DM Planning

18 April 2023

**RESPONSE TO Request for Information FOR DA 2023/0170
Demolition and construction of a dwelling house at 20 Marmora Street, Freshwater.**

Figure 5. The bins show the approximate location of the proposed side setback breach

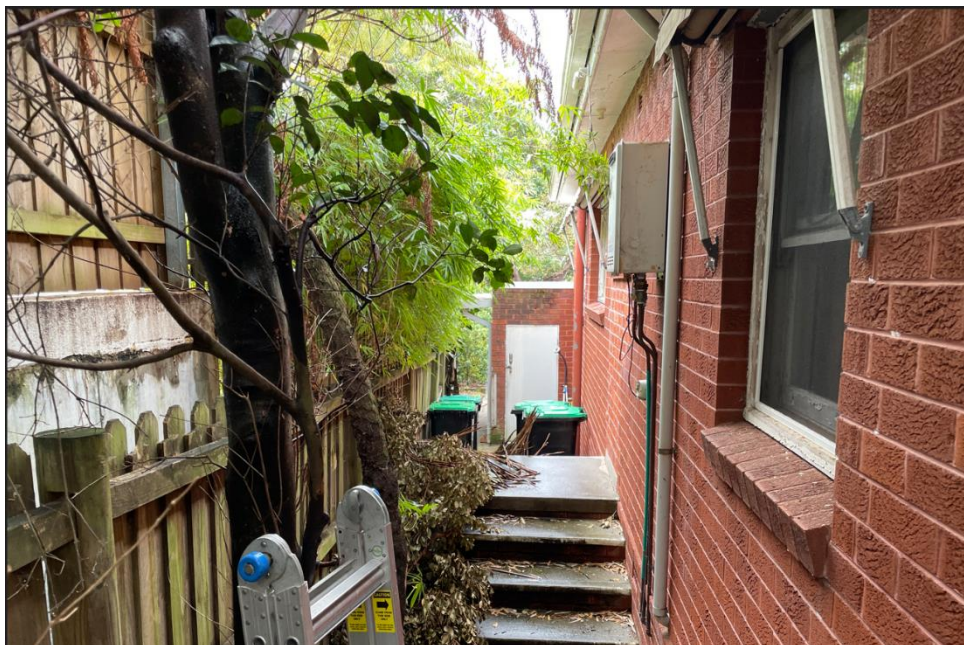
The proposed bedroom 4 breach will not obstruct views. As seen in Figure 5 below, the location of the minor side boundary setback breach is adjacent the elevated concrete driveway and retaining wall and screened with bamboo.

Bedroom 4 has been redesigned with the setback to the western boundary increased from 701mm to 838mm. The sliding door has been relocated to where the house steps in at bedroom 4, so that the door is more than the required 900mm from the boundary. The total portion of the house located within the 900mm setback accounts for a total of 0.03m².
